• • ADDENDUM # 2 ••

**PROJECT NUMBER: 130012-59
EASTERN REGIONAL WATER RECLAMATION FACILITY
OPERATIONS BUILDING RENOVATION
DUE DATE: 08/27/2025 @ 1:30 PM**

**EASTERN REGIONAL WATER RECLAMATION FACILITY
OPERATIONS BUILDING RENOVATION
PROJECT NO. 130012-59**

**CHANGES TO BID DOCUMENTS – SPECIFICATIONS AND CONTRACT
DOCUMENTS**

HVAC FIRST FLOOR PIPING NEW WORK PLAN
Eastern Regional Water Reclamation Facility Operations Building Renovation

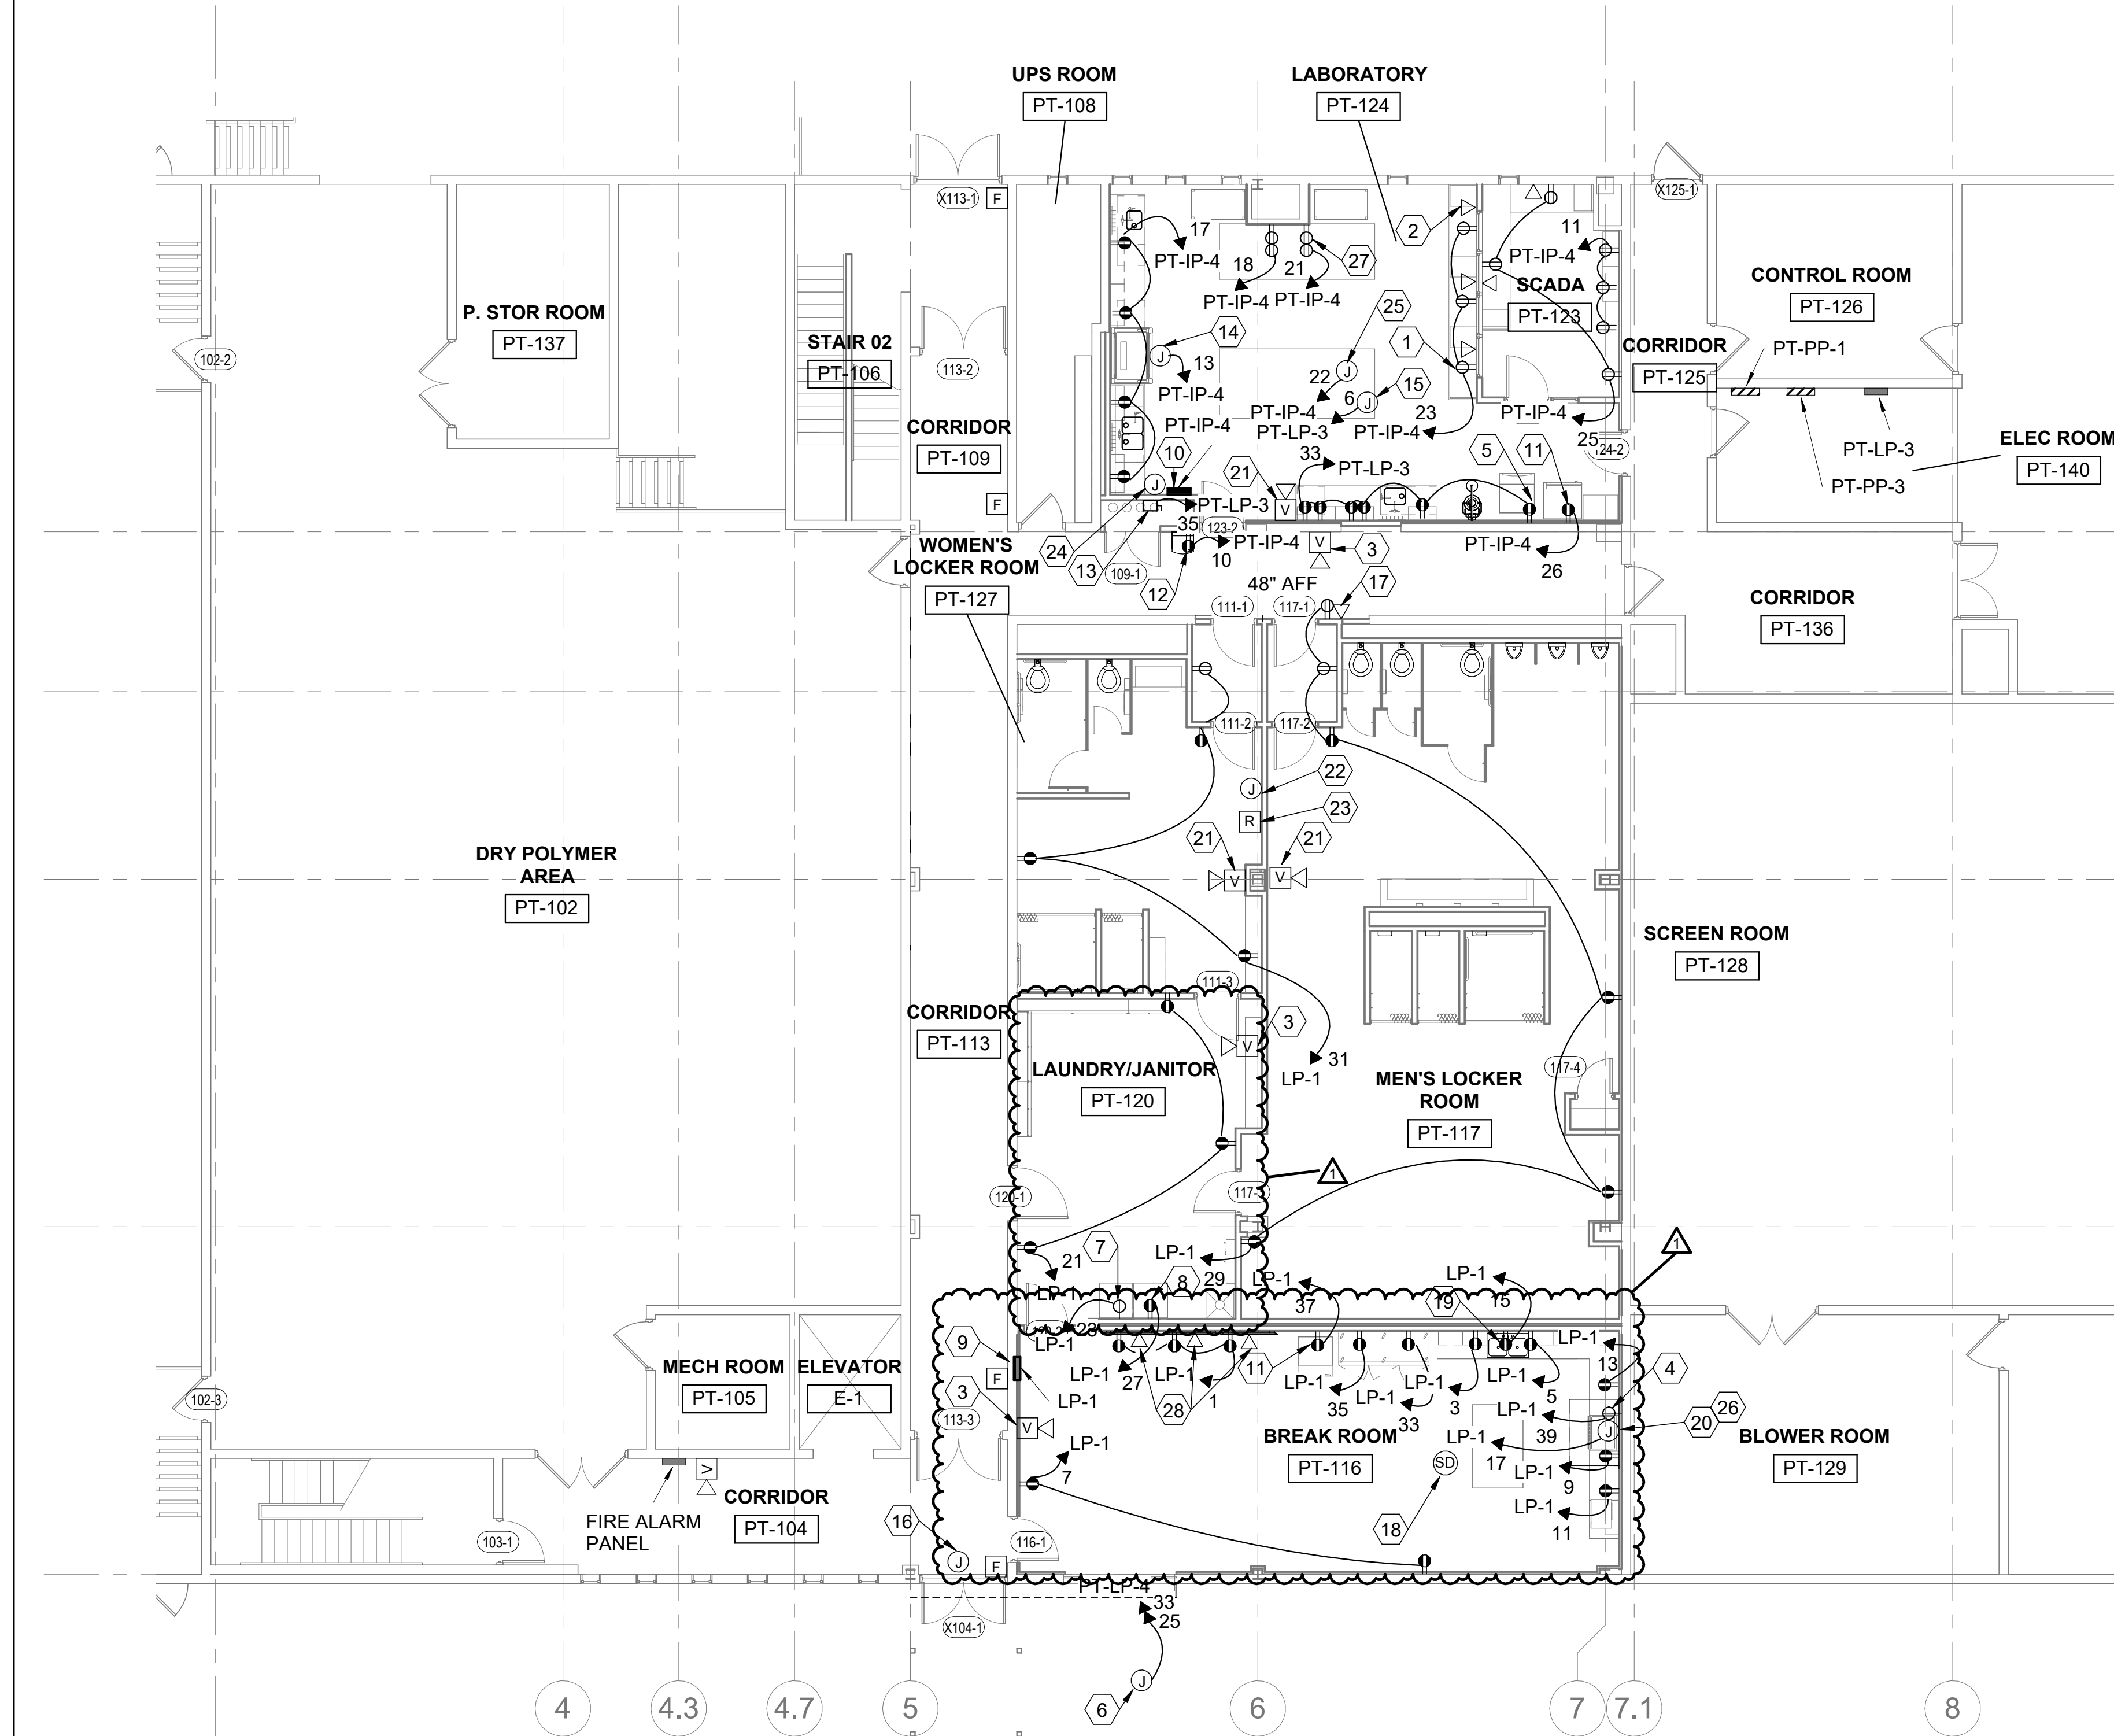
- a. Show VAV box PT-VAV-8 as being removed.
15. Sheet E-200 ELECTRICAL FIRST FLOOR POWER NEW WORK PLAN
- a. Car charger feeder size and circuit breaker size changed to 70A circuit breaker.

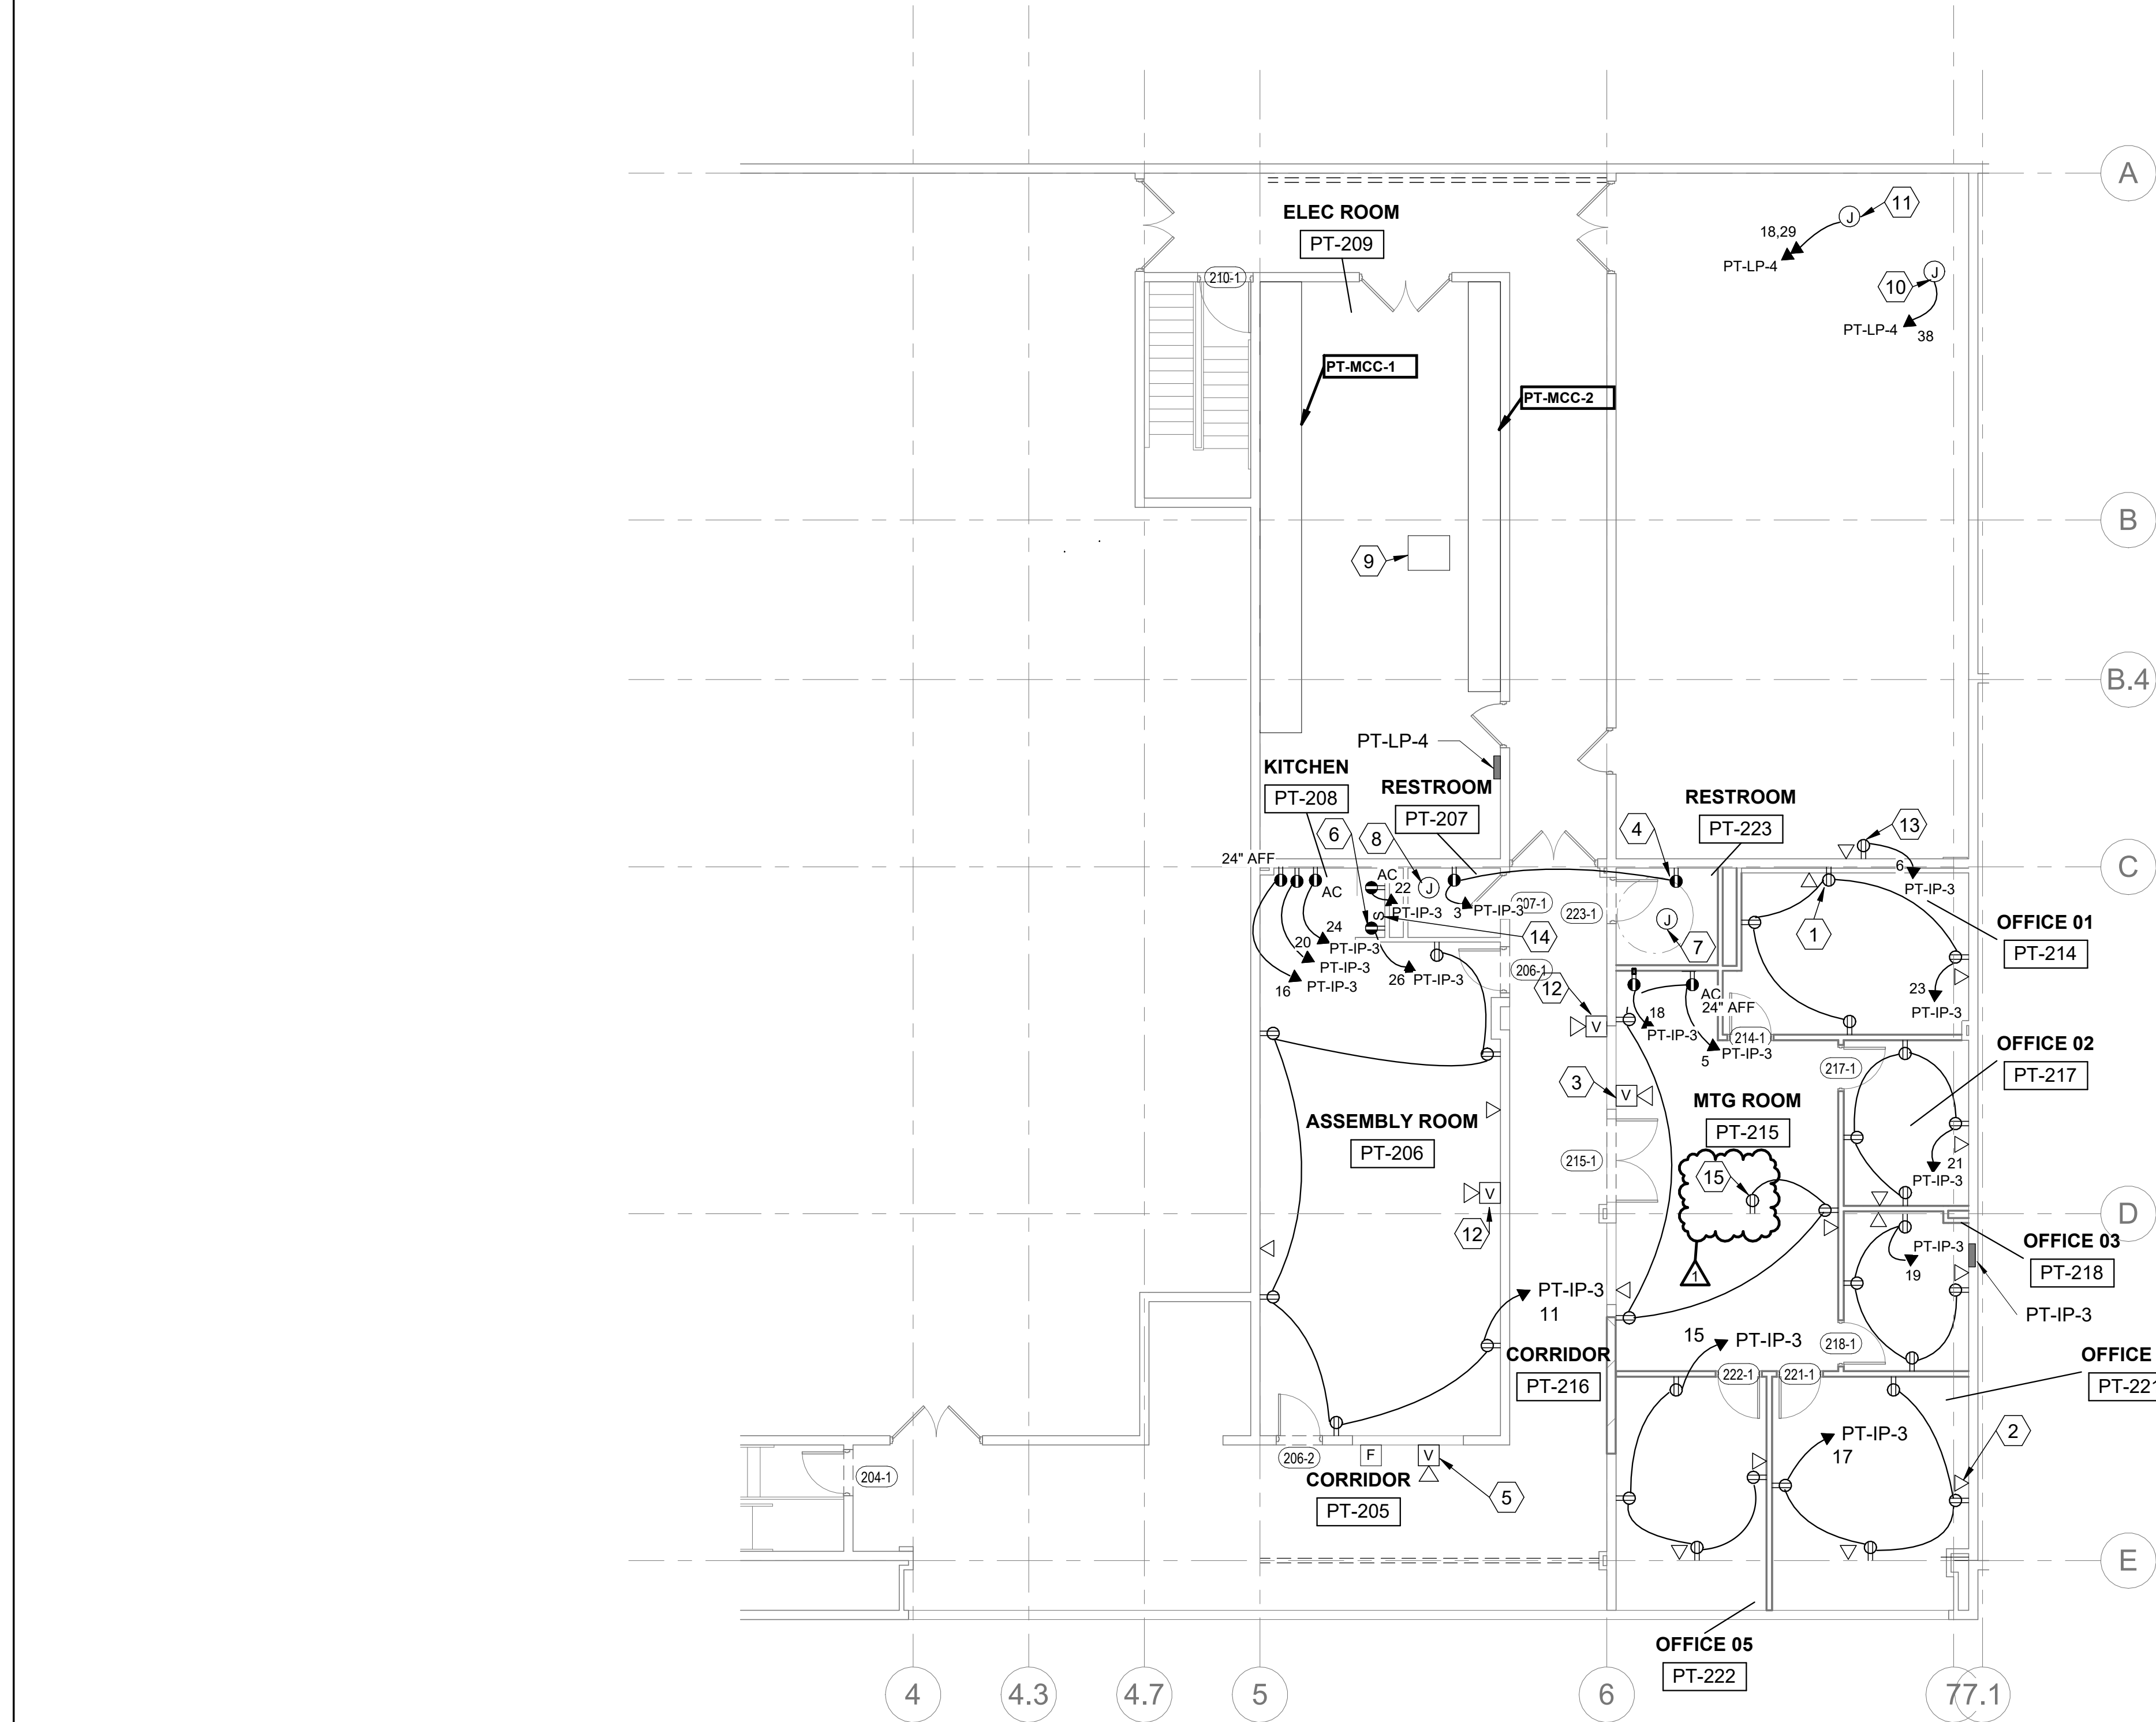
- b. Revise plan note 6.
 - c. Replace duplex receptacles with GFCI receptacles in laundry room and break room.
16. Sheet E-202 ELECTRICAL FIRST FLOOR POWER NEW WORK PLAN

5. TYPICAL TO ALL: PROVIDE 20A, 120V GROUND FAULT PROTECTED DUPLEX RECEPTACLE AND WIRE COMPLETE.
6. INSTALL OWNER-FURNISHED PEDESTAL MOUNTED LEVEL 2 CHARGING STATION IN THIS LOCATION. PROVIDE (2) 70A, 2-POLE CIRCUIT BREAKER. PROVIDE NEW FEED (3) 4 AWG & (1) 8 AWG GND IN EXISTING CONDUIT FROM PT-LP-4 TO ABOVE BREAKROOM CEILING. PROVIDE NEW CONDUIT FROM BREAK ROOM TO EV CHARGING STATION AND WIRE COMPLETE. ROUTE EXTERIOR CONDUIT DOWN WALL TO BELOW GRADE AND ROUTE BELOW GRADE TO PEDESTAL. COORDINATE EXACT LOCATION WITH OWNER PRIOR TO ROUGH-IN.
